Product Group: RIDE-ON TROWELS

Model: HTXD6i & STXD6i

TROWEL MACHINE CONTROL UNIT (MCU) CHANGE

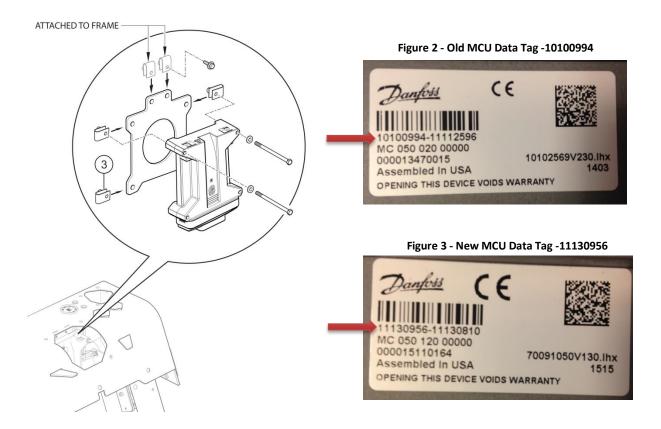
The Machine Control Unit (MCU) used in the D6i series Ride-on trowels has been discontinued by the controller manufacturer.

- Up to S/N NB2003439 the last unit production with the old MCU 10100994
- Beginning with S/N NB2003440 the starting production with the new MCU 11130956

This will not affect any operator's functions of the trowel. However, the service technician may need to identify the installed MCU part number when making future firmware or parameter updates

The MCU controller version part number can be viewed by unmounting the controller and reading the data tag on the back side or a technician can also read the hardware version part number using the Whiteman Service Tool (WST) program.

Figure 4 With the WST program open, under the ECU List tab locate the Part Number.

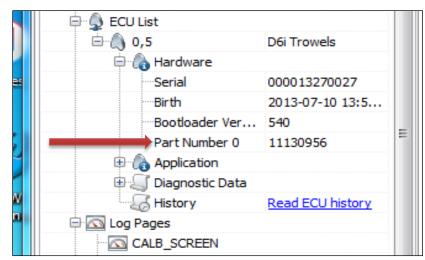
- 10100994 is the old Part Number and discontinued from the manufacturer.
- 11130956 is the new Part Number under MQ Part # 42072.

If a "No valid target ECU found" appears under the Status, it's an indication of software to hardware mismatch.

- Old Controller Hardware: 22706
 - Latest firmware for old hardware: 22707103
 - Latest HTX parameter set for old hardware: 32584101
 - Latest STX parameter set for old hardware: 32585101
- New Controller Hardware: 42072
 - Latest firmware for new hardware: 30441100
 - Latest HTX parameter set for new hardware: 32799100
 - Latest STX parameter set for new hardware: 32800100
- Service Tool Application File for both hardware versions: 22708RevE
